## REMARKS/ARGUMENTS

### 1. Objection to the Drawings

FIG. 11

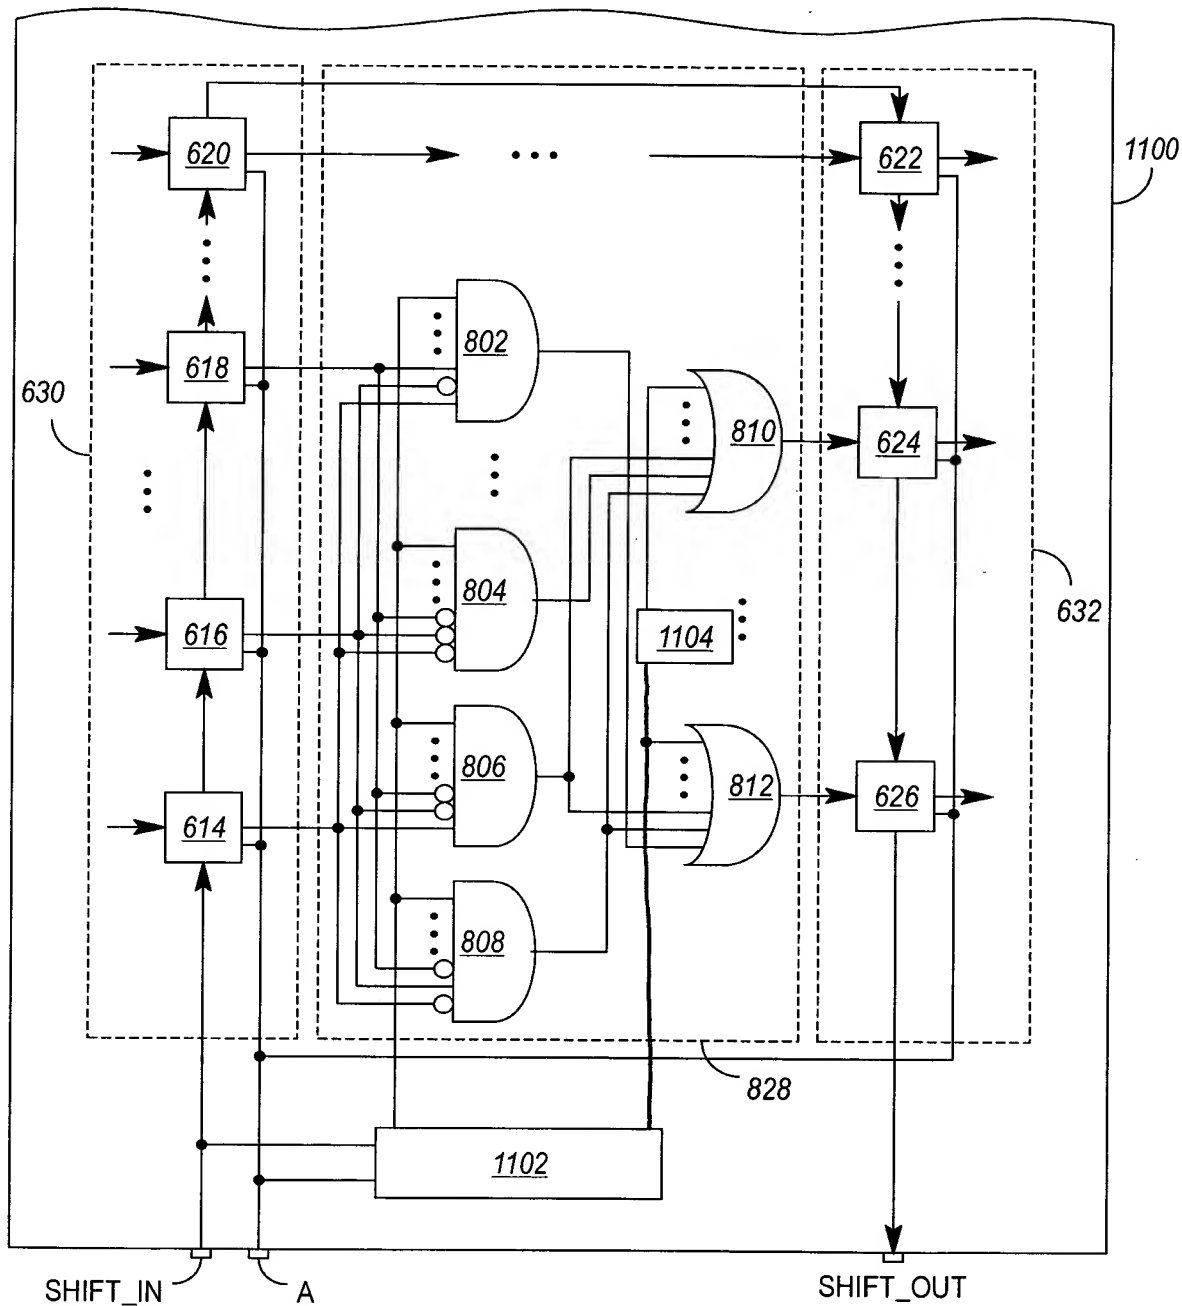
FIGS. 10 & 11 stand objected to under 37 CFR 1.83(a) for not showing "delay element 1004" (p. 15, line 24) and "logic element 1104" (p. 15, line 27).

In response to the Examiner's objection, applicant reviewed FIGS. 10 & 11 and found element 1004 in about the middle of FIG. 10, and element 1104 in about the middle of FIG. 11. Thus, no correction for these omissions is believed to be necessary. Applicant does note, however, that a line connecting element 1102, element 1104, and an input of element 812 is missing in FIG. 11. An amendment to FIG. 11 to add this line has therefore been made. It is believed that the addition of this line does not introduce new matter, as a similar line is shown in FIG. 10, and it is believed that one of ordinary skill in the art would readily recognize that this line was missing.
